TECHNICAL STAFF REPORT

Planning Board Meeting of October 16, 2008

Case No./Petitioner: **ASDP-00-101/Paul & Maureen Pusateri**

Subject: Amended Site Development Plan
ASDP-00-101, Village of River Hill Section 4, Area 4, Lot 167

DETAILED PLOT PLAN – VRH 4/4 Lot 167 – 12165 Flowing Water Trail, Clarksville, MD 21029

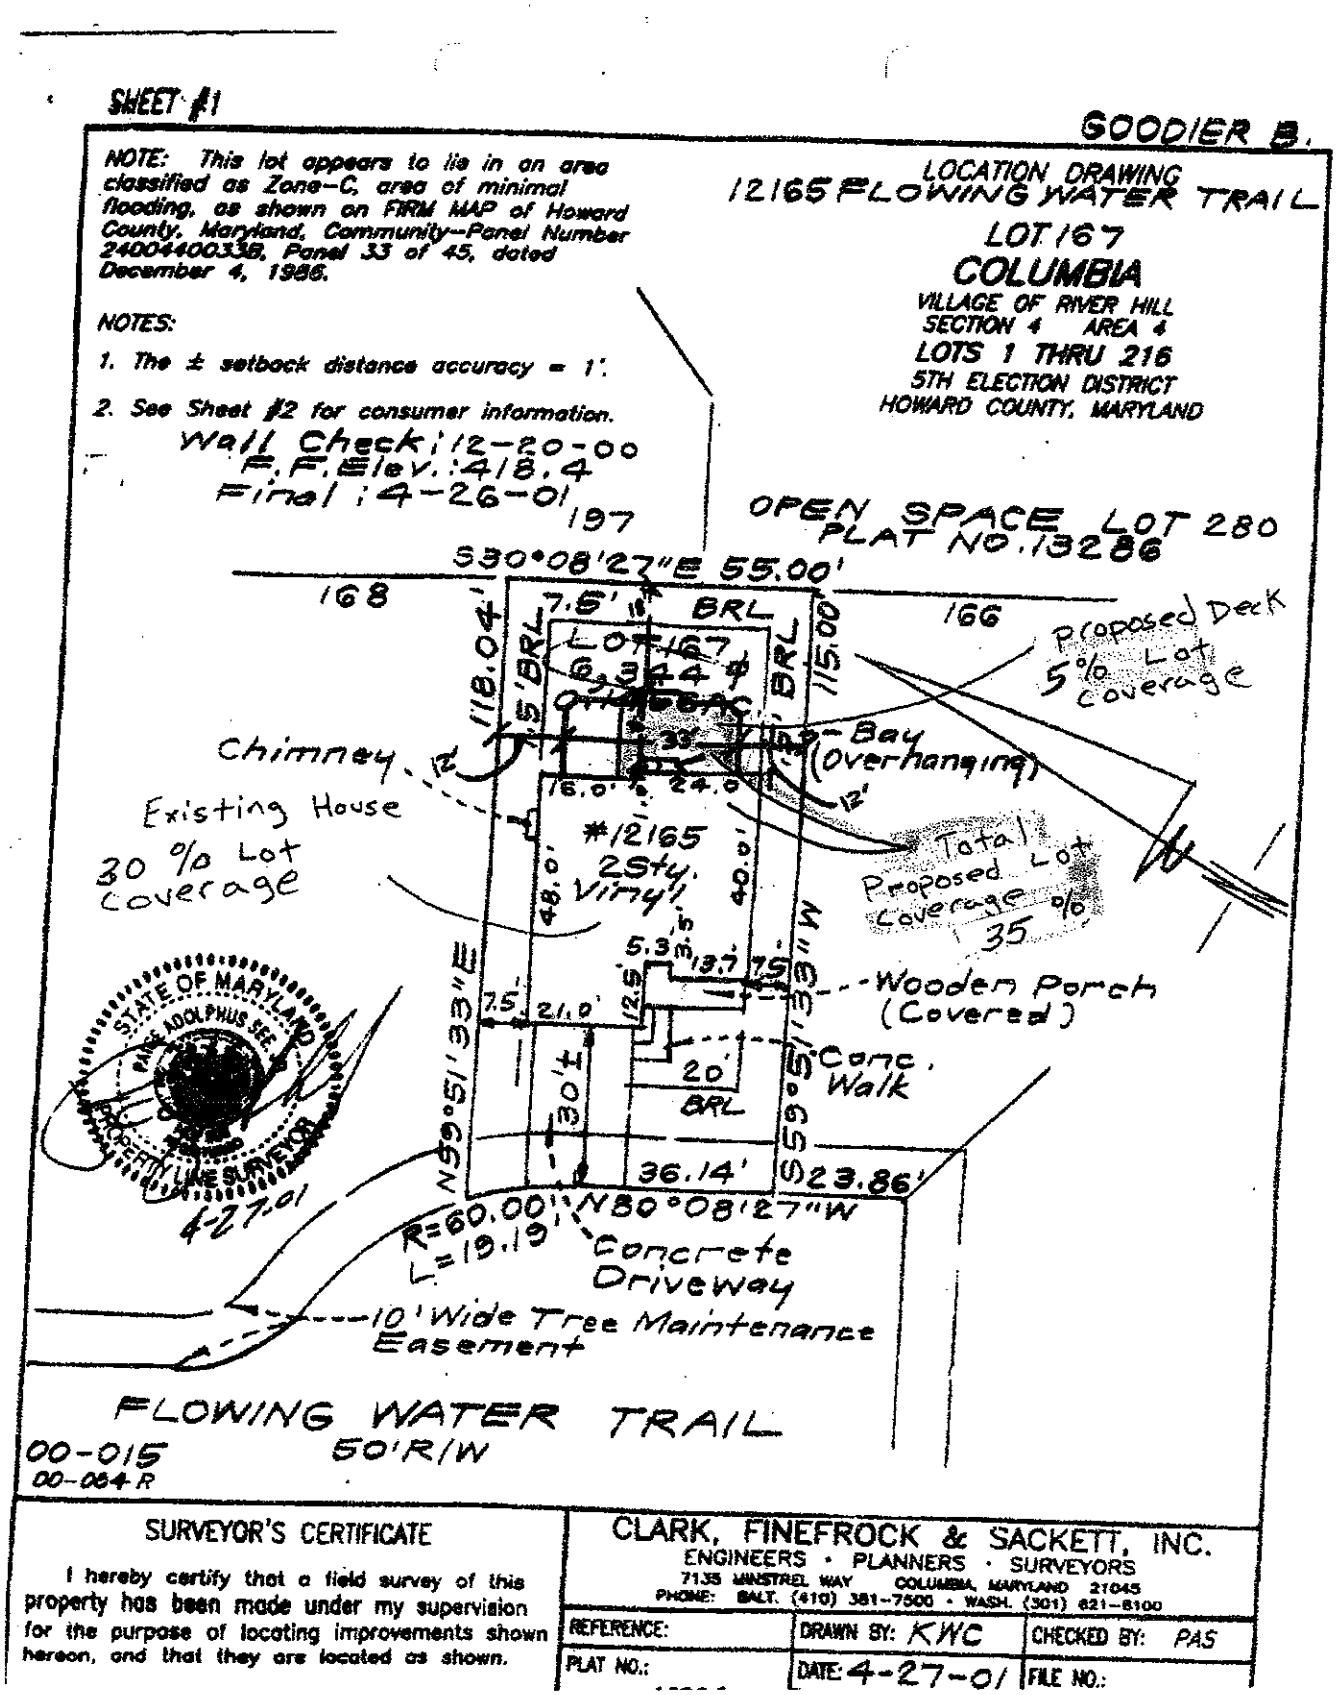
The applicant proposes to construct a two(2) tiered deck extending from the rear of the home. The overall deck will measure approximately 14' x 33'. The upper portion is 316 square feet (approx. 22.5' x 14') with a maximum height of 2'-1" (25") off the ground and will include a railing. The lower portion is 163 square feet (approx.11.5' x 14') with a maximum height of approx. 1'-2½" (14.5") off the ground, will not include a railing and will function similar to a patio. Because the lower portion will be less than 18" in height, it will not be considered a "structure" (per the Zoning Regulations); and is, therefore, excluded from coverage calculations.

A. At the time of construction of the existing, single-family, detached house the maximum lot coverage was utilized. The applicant is now requesting to add a 2 tiered rear deck addition. With this addition the lot coverage will increase to 35% -- exceeding the Final Development Plan criteria that limit lot coverage by major structures to not exceed 30% of the total lot area.

Based upon the above findings, the Department of Planning and Zoning recommends that the Planning Board approve the Amended Site Development Plan (ASDP-00-101) to allow the addition of a 2-tiered deck thus increasing lot building coverage from 30% to 35". Approval shall be contingent on the submission of a red-line revision for SDP-00-101 showing the proposed improvements.

DECK – Elevation / Details

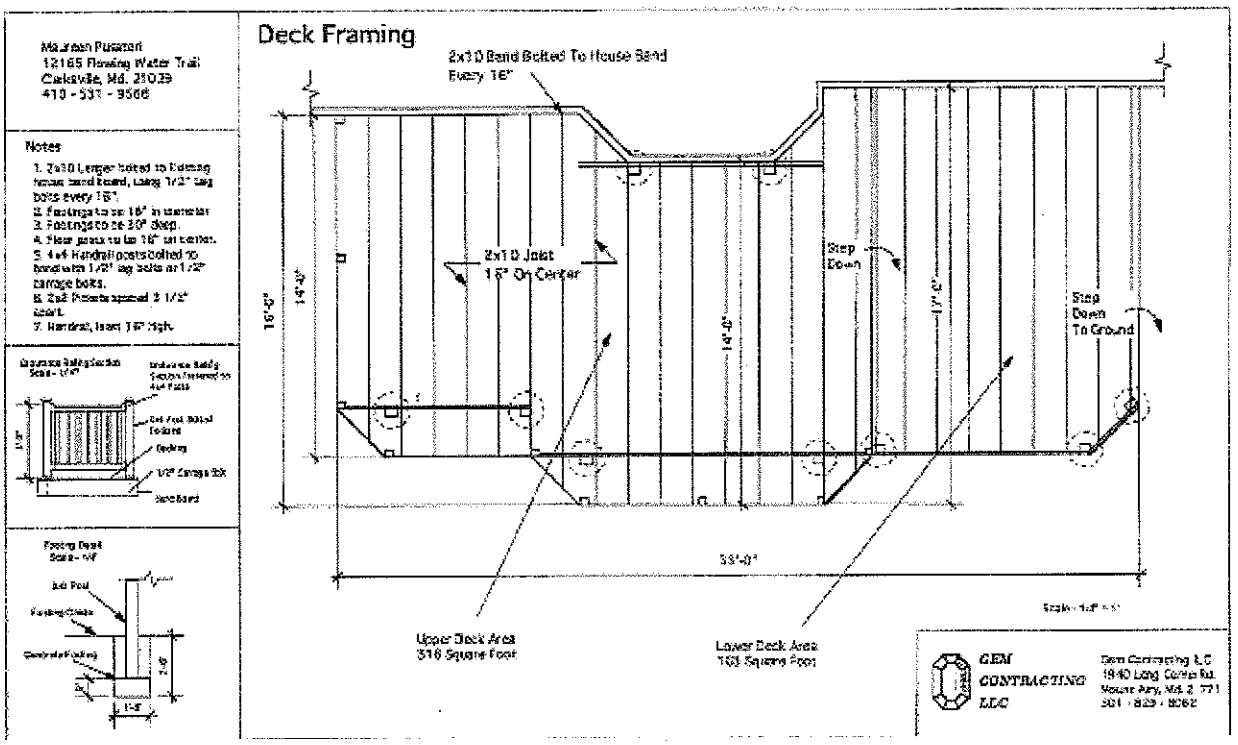
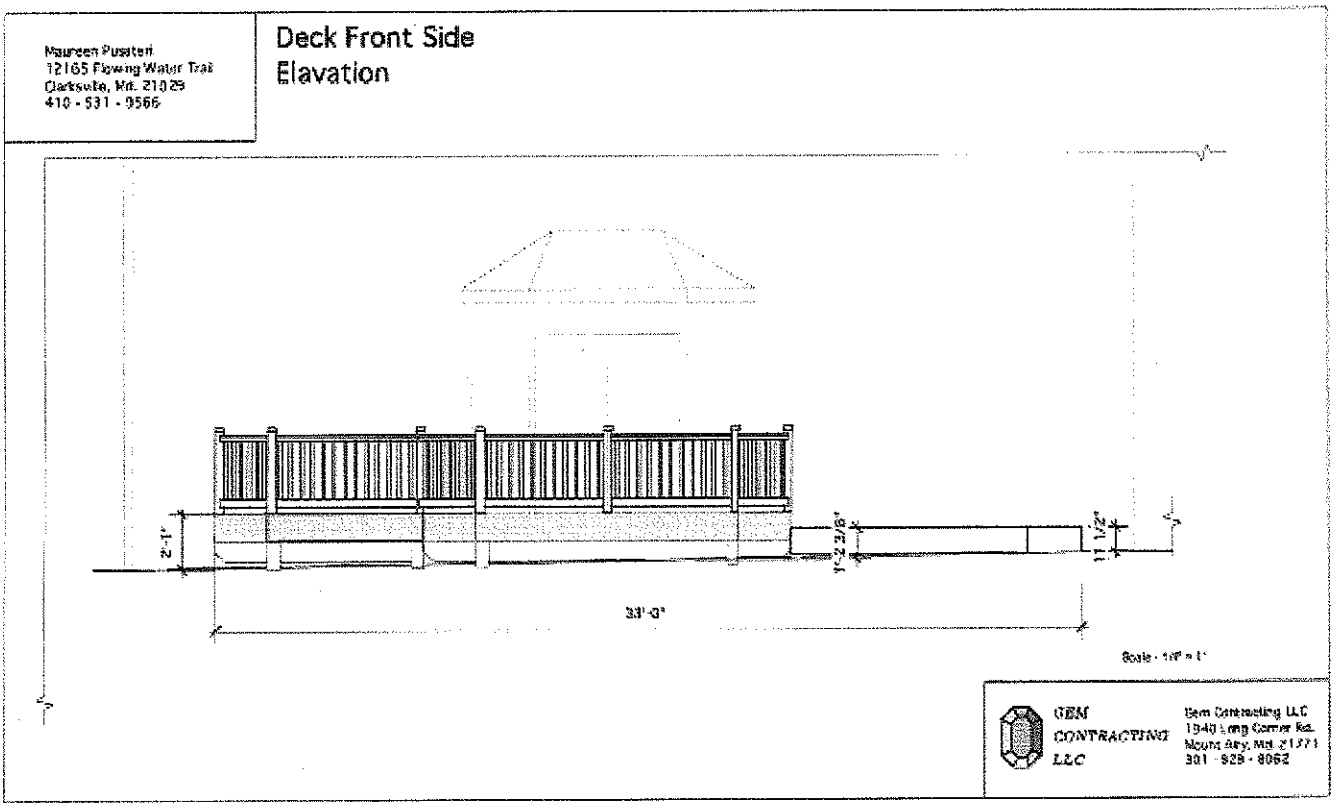
In addition to the above, the proposed color of the deck boards will match the siding and the railing will be the same color as the house trim. The railing will also be the same style and color of neighboring decks. The deck will not be on "stilts" and requires railing only on the upper portion. The deck will be visible from the rear yards of only two neighbors (one adjacent to and one opposite the applicant's rear lot). The deck addition will not alter the character of the developed residential neighborhood, will not impair the use of the adjacent and surrounding developed residential lots and there will be no negative visual impact. The proposed structure is not detrimental to the public welfare. The owner states in the Application that the Architectural Committee has approved the size and design of the proposed 2-tiered deck.
